Access Compliance Report Public Rights-of-Way (Island Curb Cuts)

Intersection ID: 7951 Main Street: BEATTIES FORD RD **Cross Street: HOLLY_ST** Location: ADA ID: 6FA6F7456081 Curb Cut Type: MedianRefuge2 Initial Pass/Fail: Pass **Overall Compliance: No** Severity Score: 0.25

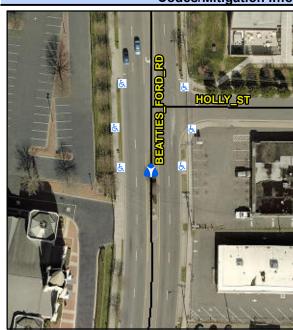
3 ()			- 1 ()	
Yes	Refuge 1 Slope (%)	4.9	Yes	Gutter 1 Slope (%)	0.6
Yes	Refuge 1 X Slope (%)	0.4	Yes	Gutter 1 X Slope (%)	1.0
N/A	Painted X Walk1?	No	Yes	DWS 1 Provided?	Yes
N/A	X Walk 1 Direction	To E	Yes	DWS 1 Contrast?	Yes
N/A	X Walk 1 Width (In)	N/A	Yes	DWS 1 Length (In)	24.0
N/A	Road 1 Slope (%)	0.7	Yes	DWS 1 Full Width?	Yes
N/A	Road 1 X Slope (%)	3.5	No	DWS 1 Offset (In)	7.0
Yes	Refuge 2 Length (In)	54.0	Yes	Gutter 2 Ponding?	No
Yes	Refuge 2 Width (In)	72.0	Yes	Gutter 2 Lip Ht (In)	0.0
Yes	Refuge 2 Slope (%)	3.3	Yes	Gutter 2 Slope (%)	1.2
Yes	Refuge 2 X Slope (%)	0.6	Yes	Gutter 2 X Slope (%)	0.0
N/A	Painted X Walk2?	No	Yes	DWS 2 Provided?	Yes
N/A	X Walk 2 Direction	To W	Yes	DWS 2 Contrast?	Yes
N/A	X Walk 2 Width (In)	N/A	Yes	DWS 2 Length (In)	24.0
N/A	Road 2 Slope (%)	0.4	Yes	DWS 2 Full Width?	Yes
N/A	Road 2 X Slope (%)	1.7	No	DWS 2 Offset (In)	7.0
N/A	Refuge 3 Length (in)	N/A	N/A	Gutter 3 Ponding?	N/A

Remove & Replace Detectable Warning System.
